European Union Aviation Safety Agency
Notice of Proposed Amendment 2024-03 (B)
in accordance with Article 6 of MB Decision 01-2022

NPA 2024-03 (B) — PROPOSED AMENDMENTS

Figure 1 TYPICAL LIFERAFT – ARRANGEMENT OF RETRO-REFLECTIVE TAPE

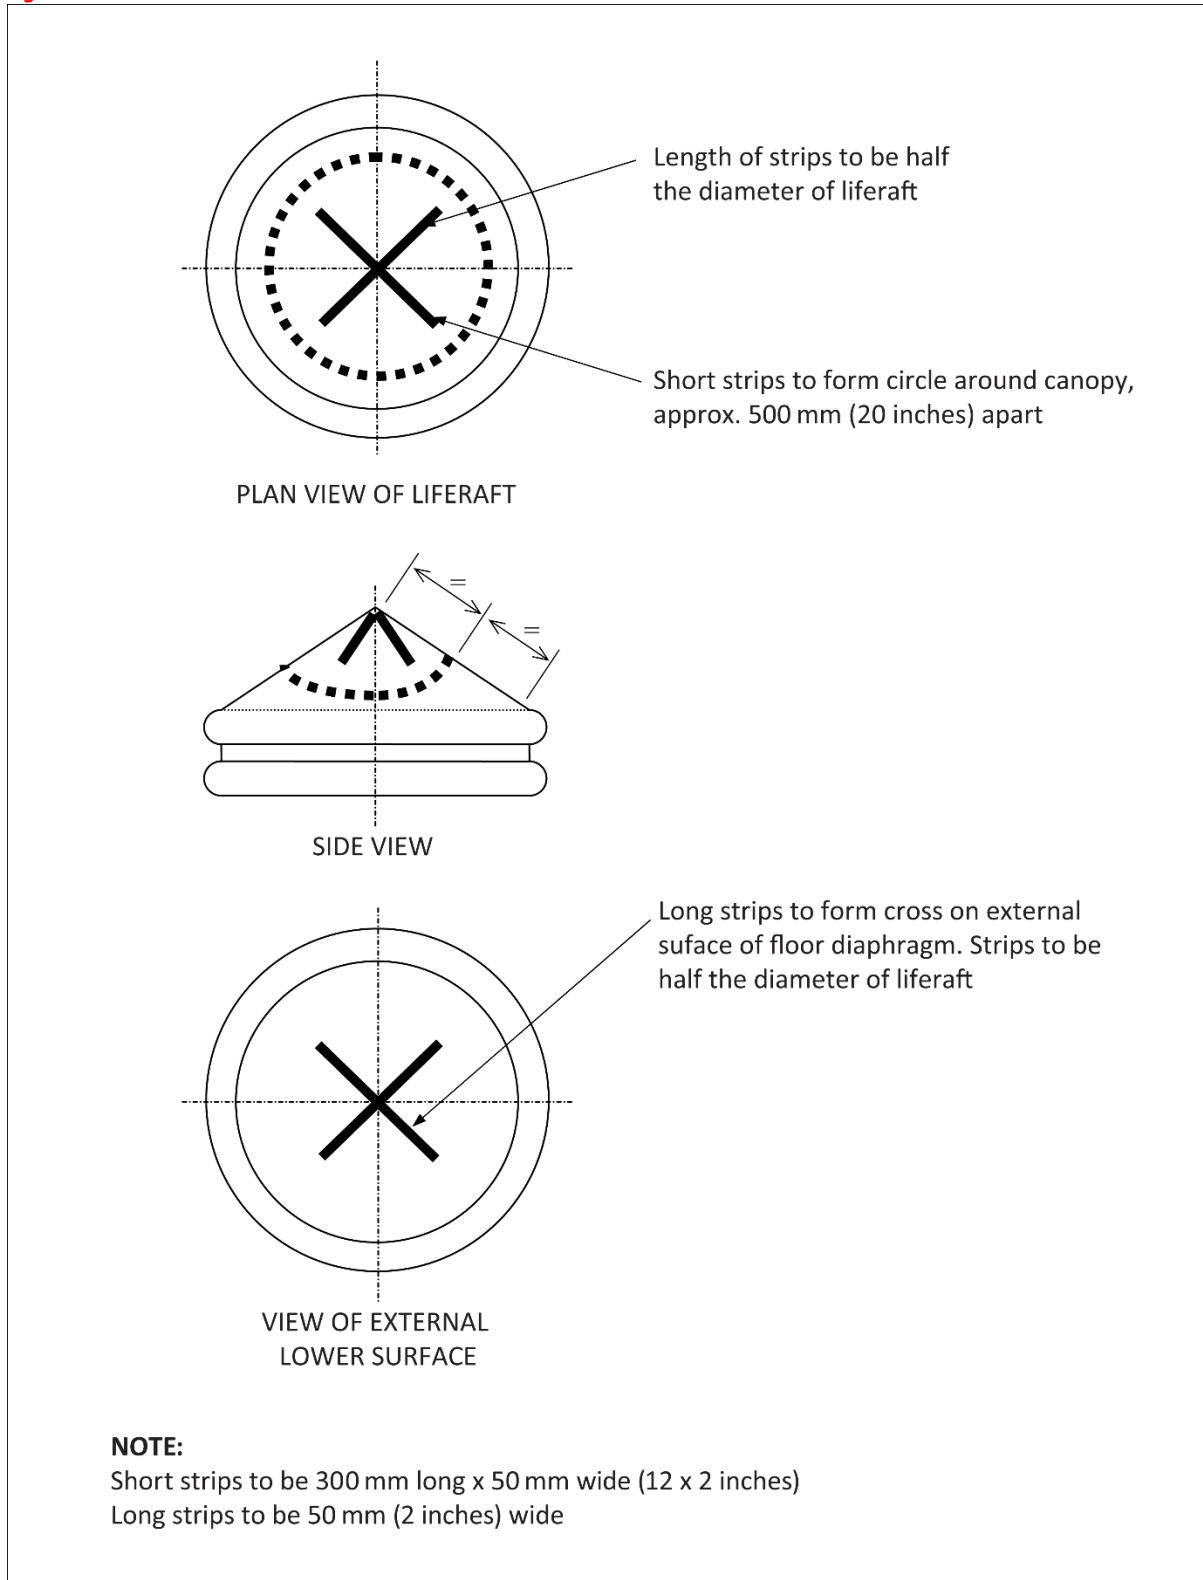
3.6.2 The arranged pattern of the retro-reflective material shall be generally as shown in Figure 1.
